Access Compliance Report

Public Rights-of-Way

(Pedestrian Signals)

Intersection ID: N/A	Main Street:	Cross Street: N/A	Location: N/A
ADA ID: 45A6FFD5C681	Signal Type: Two Push Buttons-Non APS	Overall Compliance: No	Severity Score: BTN 1:N/A BTN 2: N/A No BTN: N/A
Codes/Mitigation Info/Possible Solution		Field Measurements/Component Compliance

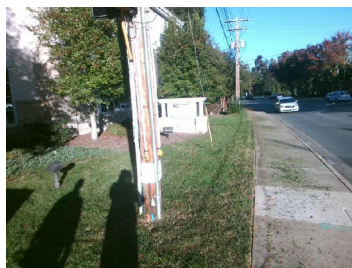
PROW/ADA: TMUTCD 4e.08, R404.3, R404.1, R404.7.1, R404.7.2

Yes	B 1 Clear Xing Direction?	ClearlyMarked	Yes	B 2 Clear Xing Direction?	ClearlyMarked
	B 1 Crossing Direction	To SE		B 2 Crossing Direction	To NE
Yes	B 1 DistanceTo XWalk (in)	18.0	No	B 2 DistanceTo XWalk (in)	252
No	B 1 DistanceTo Curb (in)	138.0	No	B 2 DistanceTo Curb (in)	138.0
Yes	B 1 Diameter (in)	2.0	Yes	B 2 Diameter (in)	2.0

Possible Solutions: Replace Signal Push Button With APS Button on New Post. Remove & Relocate Sign.
